Mike Monnie
Edwards Greenhouses
4106 Sand Creek
Boise, Idaho 83703

June 5, 1994

I have reviewed the data provided by the State of Idaho as part of the record for Water District No. 63-S (Stewart Gulch) hearing. I have reduced the March 26, 1994 data to a set of graphs. As you know, I was not at the hearing and was unable to review the hearing tapes. Nevertheless, I have provided the following comments and recommendations regarding the data I reviewed.

Figure 1

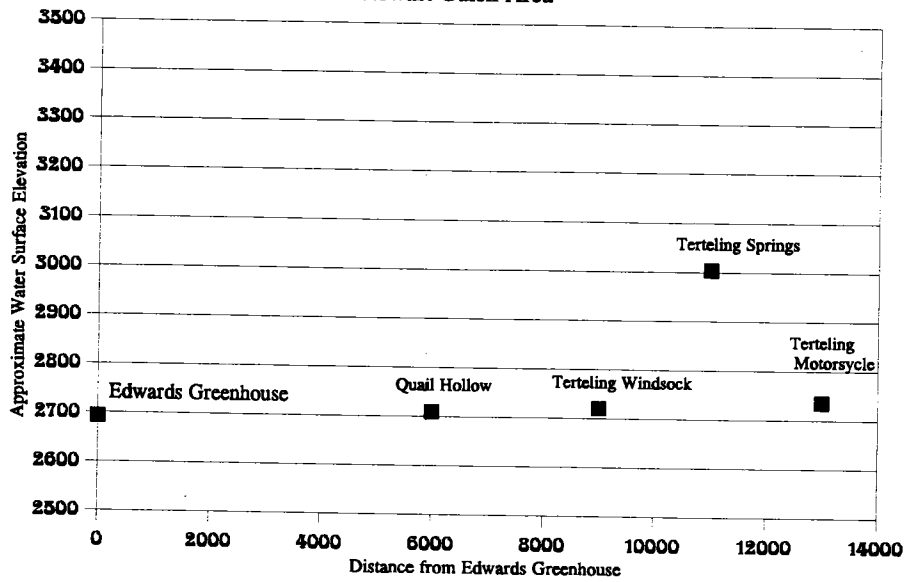
The tests conducted withdrew water from the Quail Hollow and Terteling Windsock well. No apparent effects on the Terteling Springs or Terteling Motorcycle Club well were noted. The other wells examined (Edwards Greenhouses, Flora Greenhouses, Hillside Jr. High, and Terteling Pool wells) appear to be affected by the Quail Hollow and Terteling Windsock Wells (figure 1).

The initial conclusion would be that the wells to the southwest of Terteling Springs do not interfere with Terteling Springs and Terteling Motorcycle Club well. However, one cannot conclude, based only on the data I reviewed, that water removal from the Terteling Springs and Terteling Motorcycle Club wells would not affect the wells to the southwest. Based on the estimated piezometric surfaces (see figure 2), the Terteling Motorcycle Club well could be in part of the system that supplies the other wells if there are significant differences in aquifer properties and/or supply. If this is the case, it would explain why the Terteling Motorcycle club well was unaffected by the wells used in the pumping test. In other words, the wells to the southwest may be supplied by the same source as the Terteling Motorcycle Club well, but there may be some major differences, such as a leaky boundary, separating the areas. In this case, a drawdown in the supply-limited area would not affect the other area. Conceptually, the situation would be akin to a pressure reducing valve in a pipeline, or a control gate in a reservoir system.

I would recommend doing some well tests using the Terteling Motorcycle Club well as the pumped well and using the other wells as observation wells. Also, water quality analyses
